RE: H. B. ROBINSON UNIT NO. 2
DOCKET NO. 50-261
FACILITY OPERATING LICENSE NO. DPR-23

H. B. ROBINSON UNIT 2
SPENT FUEL STORAGE EXPANSION

Responses to NRC Staff
Requests for Additional Information
and Information Submitted
to Supplement CP&L Report Titled
"H. B. ROBINSON UNIT 2 SPENT FUEL STORAGE EXPANSION"

Figure 1: Comparison of Keff Values Calculated
for Point Beach

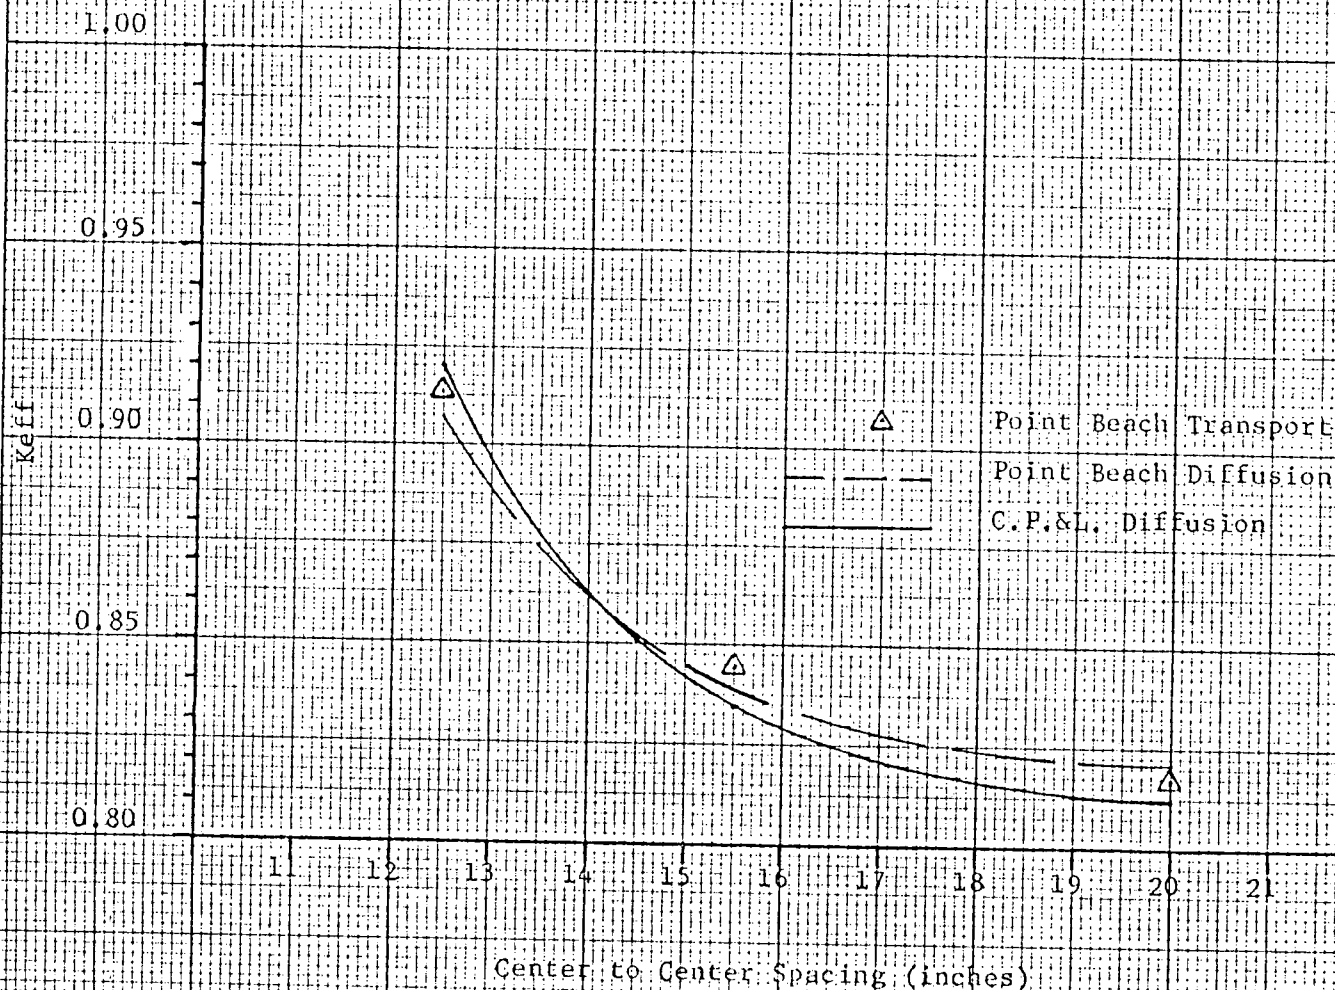
Experience has shown that diffusion theory codes, such as PDQ-7, yields nonconservative results for reactivity when there is significant spacing between assemblies as in a storage pool. Please provide values for the transport theory correction factor at the design spacing for the racks.

In a March 28, 1975 letter to the NRC (Docket No. 50-266 and 50-301), Wisconsin Electric Power Company and Wisconsin - Michigan Power Company submitted an amendment for review entitled, "Spent Fuel Storage Rack Replacement." The attachment to this letter contained K_{eff} values obtained using diffusion and transport calculations for various rack configurations.

The conditions and geometries investigated for the Point Beach pool modifications were set up using CP&L's diffusion codes. Figure 1 presents the results obtained from XPOSE/PDQ-7 and compares the results with those given in the Point Beach submittal. This comparison is excellent; therefore, it is reasonable to use the Point Beach diffusion-to-transport correction for the CP&L design. For the 15.5" spacing, this correction is $0.005\Delta k$. If this correction is conservatively added to the nuclear methods and structural absorbing uncertainties presented in our submittal (Section 3.1.3) a worst case K_{eff} of 0.925 is obtained.
